Notice of Decision

Historic Review of Exterior Alterations

HI-11-21

Type of Application:	Historic Review of Exterior Alterations to install roof-mounted solar panels.
Review Body:	Landmarks Commission (Type III review)
Applicant:	Jeffrey Lee; Blue Raven Solar; 1403 N Research Way, Orem, UT 84097
Property Owner:	Ashlee Graybeal; 321 Sixth Avenue SW, Albany, OR 97321
Address/Location:	321 Sixth Avenue SW, Albany, OR 97321
Map/Tax Lot:	Linn County Assessor's Map No. 11S-03W-07BB; Tax Lot 7000
Zoning:	Office Professional (OP) Zoning District, Monteith National Historic District Overlay

SHEET NAME
SITE PLAN

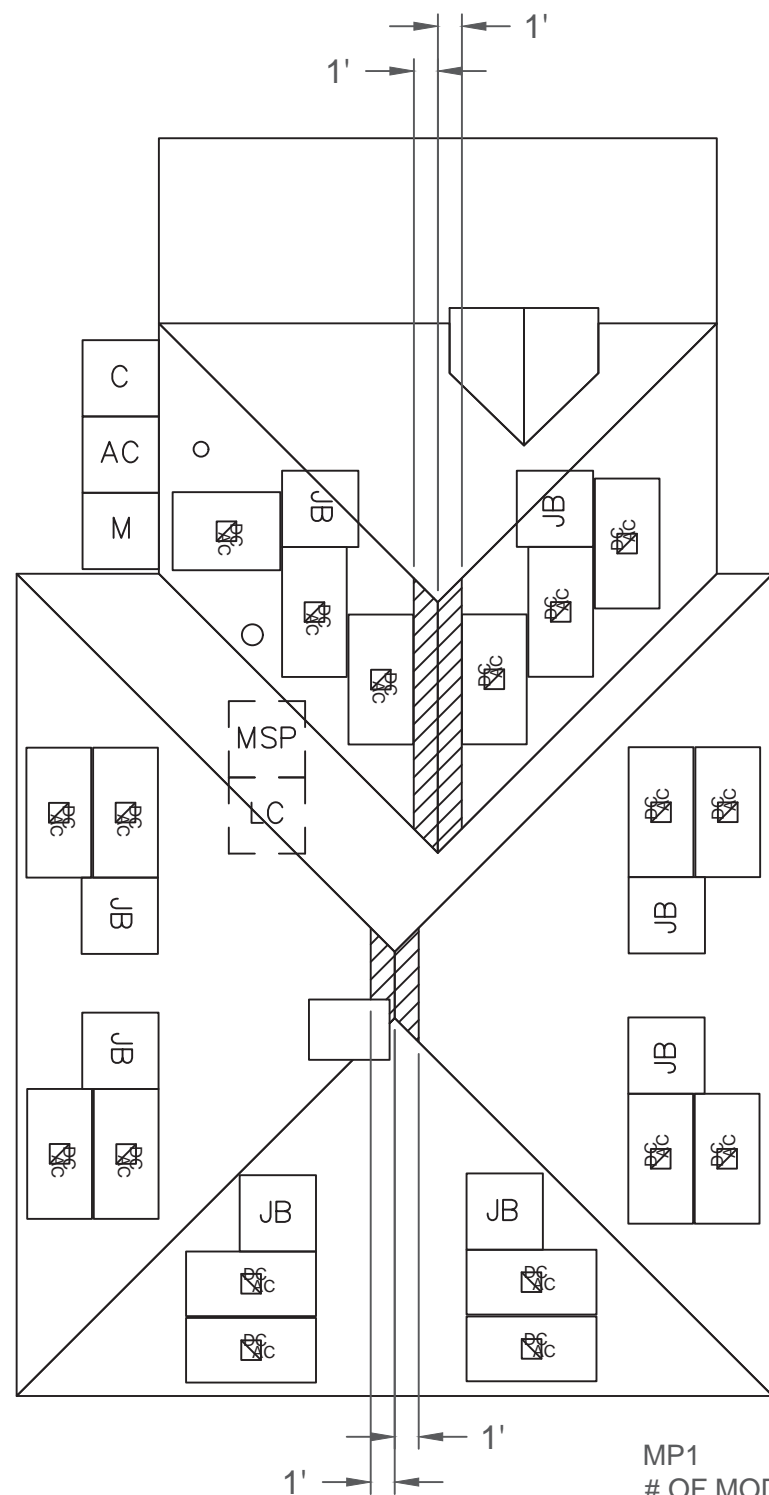
Condition 1 All junction boxes shall be placed under solar panels so that only the panels and their brackets are visible from the street.
